# Building #046 Renovations For College of Social and Applied Human Sciences Project No. 504034 Post

## **POST TENDER ADDENDUM 2**

March 13, 2019

**PATHWAYS DETAILS**

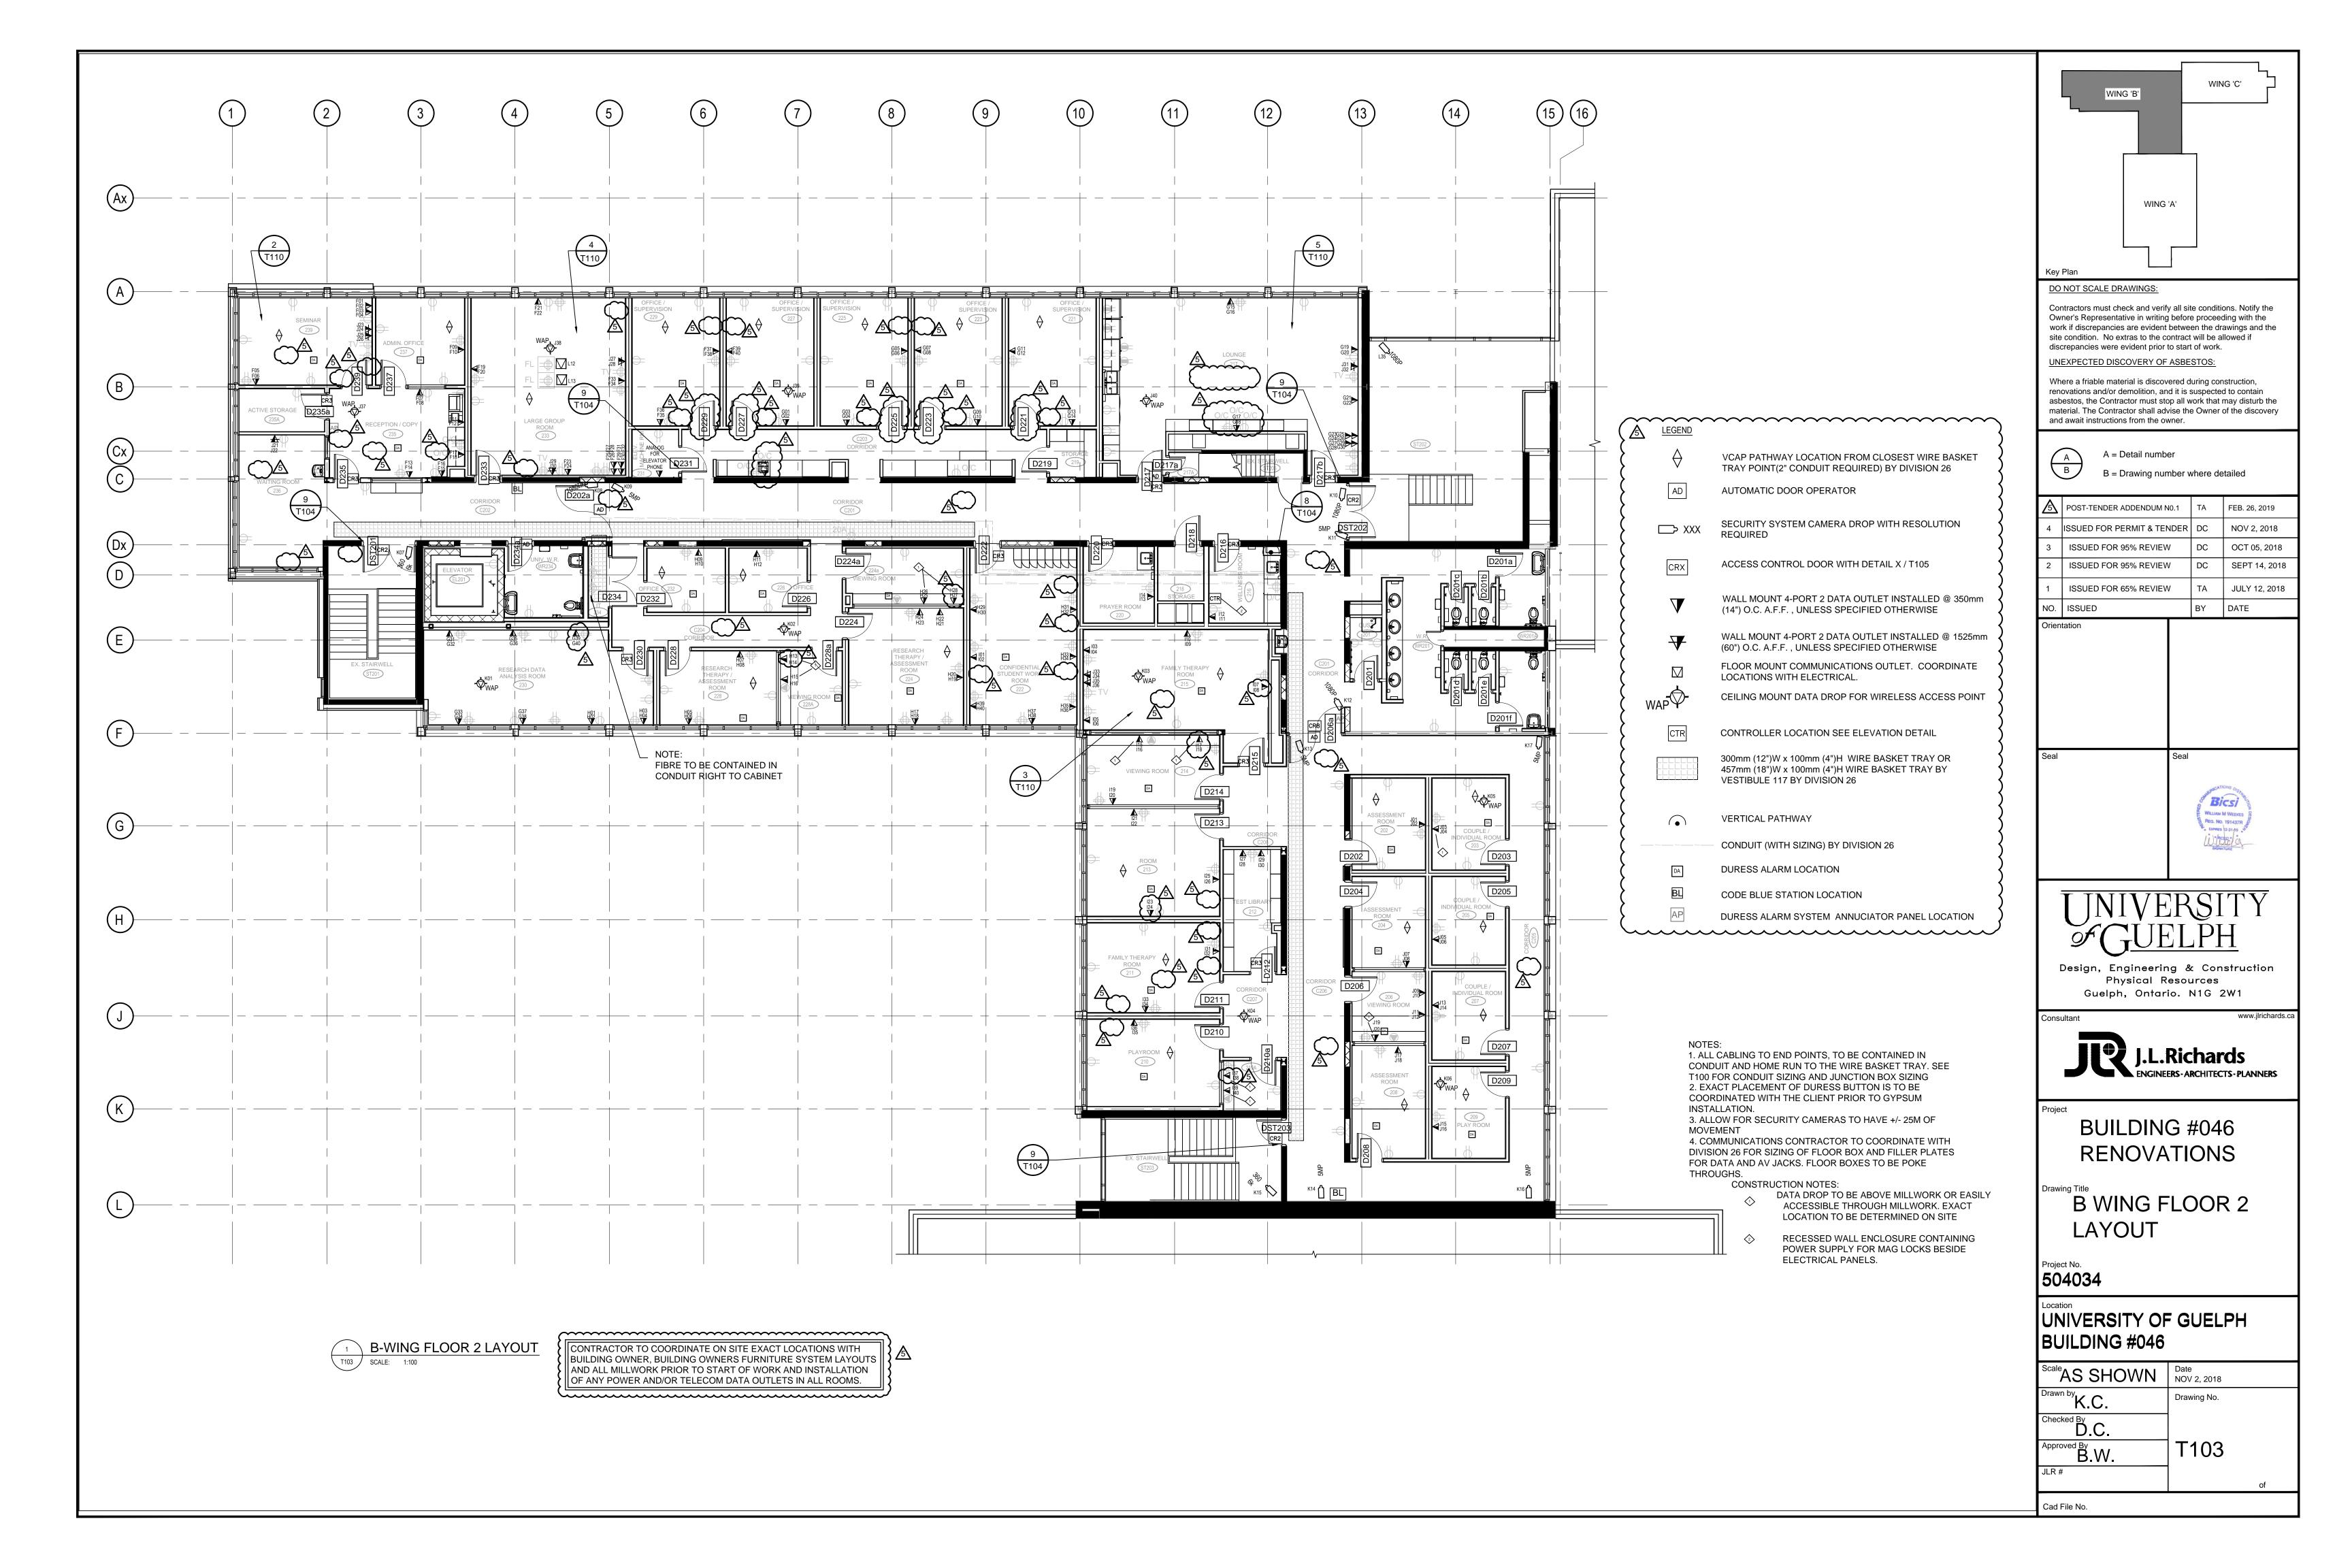
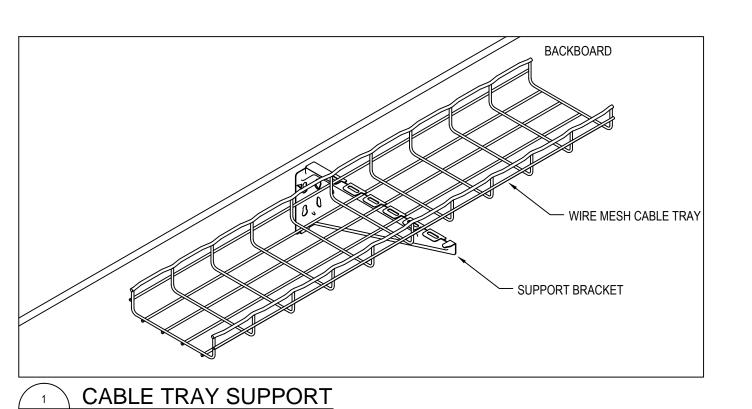
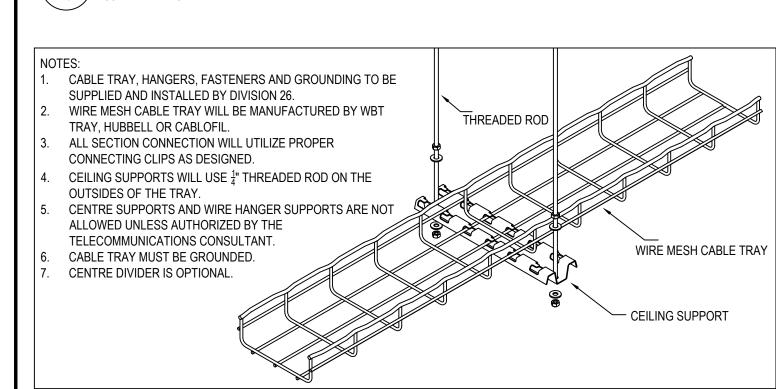
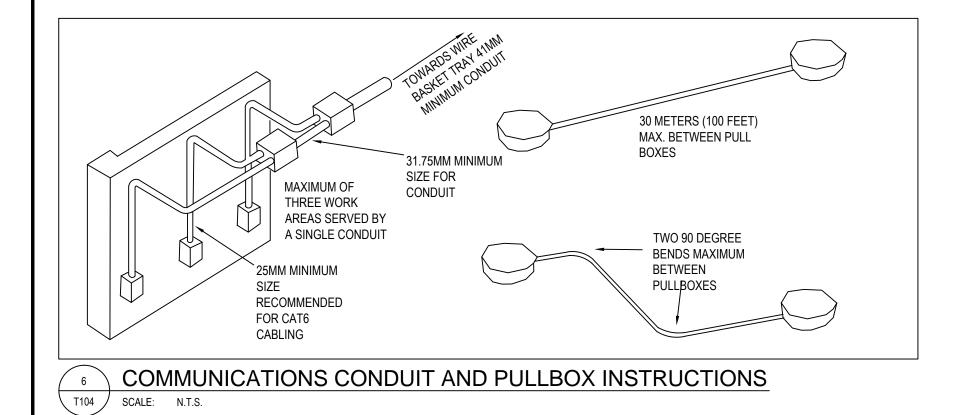
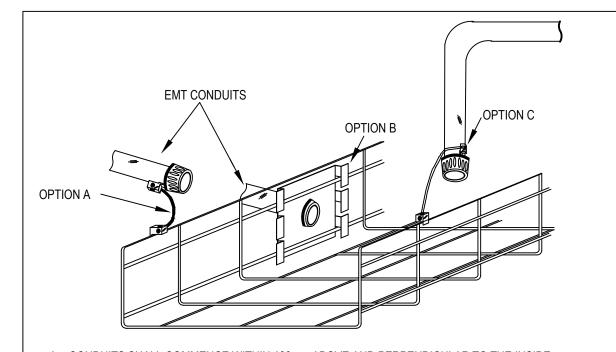
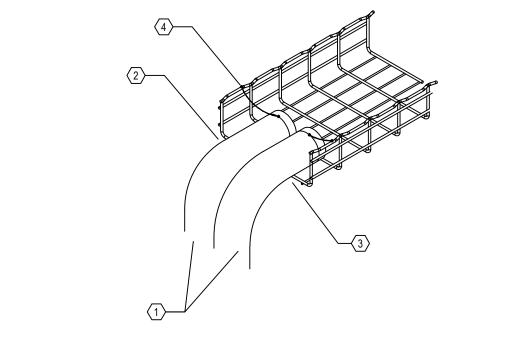
PA6 PA5 PA4PA3 PA2PA1 PA19 PA SYSTEM CAT6 FOR Z2 5 DELETED FROM PA11PA12 PA13PA14 CONTRACT CAT6 FOR Z2 PA10 PA15 PA9 PA18 PA8 CAT6 FOR Z3 PA7 PA16 PA17 SECURITRON 204A(Z1) PULL BOX SHALL NOT BE USED FOR 90 DEGREE BENDS OR FOR 'U' 204A(Z2) ELECTRICAL POWER
